# Access Compliance Report

## Public Rights-of-Way

Intersection ID: 10011741	Main Street: N_SHARON_AMITY_RD	Cross Street: N/A	Location: SE
ADA ID: 8CD09AC9781E	Ramp Type: PerpDiag	Initial Pass/Fail: Fail	Overall Compliance: No
Codes/Mitigation Info/Possible Solution		Field Measurements/Component Compliance

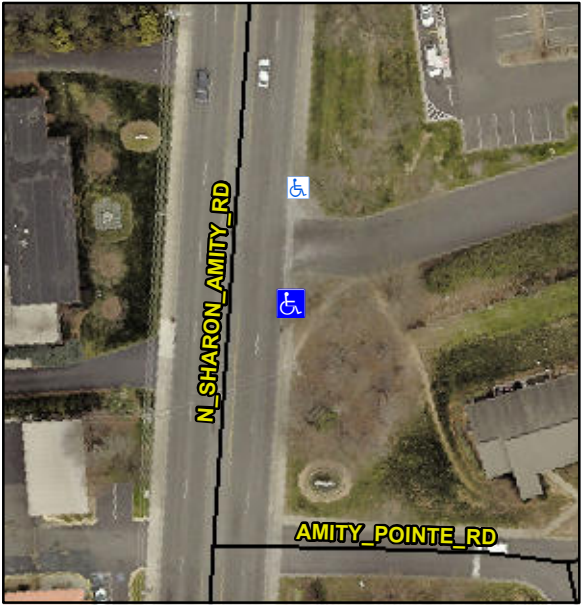
Possible Solutions:		<b>Remove &amp; Replace Curb Ramp With Two New Directional Ramps or Equivalent.</b>
	Surveyor Notes:		<b>N/A</b>
<p>Street 1 Name</p> <p>Stop Condition-Street 2</p> <p>Street 2 Name</p> <p>Stop Condition-Street 1</p>	ENTRANCE		<b>None</b>
	N SHARON AMITY RD		<b>None</b>
PROW/ADA:		<b>Not Found, R304.5.1, R304.2.2, R304.5.3, R302.7</b>	
Total Cost:		\$ 3200.00

Compliance	Description	Data	Compliance	Description	Data
N/A	Ramp Length (in)	60.0	No	Ramp Slope (%)	15.4
No	Ramp Width (in)	45.0	No	Ramp XSlope (%)	3.0
N/A	Flare Type LT	N/A	N/A	Flare Type RT	N/A
N/A	Flare Slope LT (%)	N/A	N/A	Flare Slope RT (%)	N/A
N/A	Flare Traversable LT?	N/A	N/A	Flare Traversable RT?	N/A
N/A	Landing Length (in)	N/A	N/A	DWS Provided?	N/A
N/A	Landing Width (in)	N/A	N/A	DWS Contrast?	N/A
N/A	Landing Slope (%)	N/A	N/A	DWS Length (in)	N/A
N/A	Landing X Slope (%)	N/A	N/A	DWS Full Width?	N/A
N/A	Landing Curb? (Y/N)	N/A	N/A	DWS Offset (in)	N/A
N/A	Shared Landing?	N/A			
N/A	Gutter Ponding?	N/A	N/A	Gutter Slope (%)	N/A
N/A	Gutter Lip Ht (in)	N/A	N/A	Gutter X Slope (%)	N/A
N/A	Painted X Walk1?	No	N/A	Painted X Walk2?	No
	X Walk 1 Direction	To N		X Walk 2 Direction	To W
N/A	X Walk 1 Width (in)	N/A	N/A	X Walk 2 Width (in)	N/A
	X Walk 1 Slope (%)	3.2		X Walk 2 Slope (%)	1.9
	X Walk 1 X Slope (%)	2.0		X Walk 2 X Slope (%)	0.9

N/A	Ramp inside XWalk1?	N/A	N/A	Ramp inside XWalk2?	N/A
	Road Slope (%)	2.7	N/A	Clear Space?	N/A
	Road X Slope (%)	0.1	N/A	Clear Space to XWalk (in)	N/A
N/A	Any Obstructions?	N/A	N/A	Storm Grate/Utility Hazard?	N/A
	Obstruction Type			Storm Grate/Utility Type	
		N/A			N/A
		No		Surface Condition? (G/P)	Poor
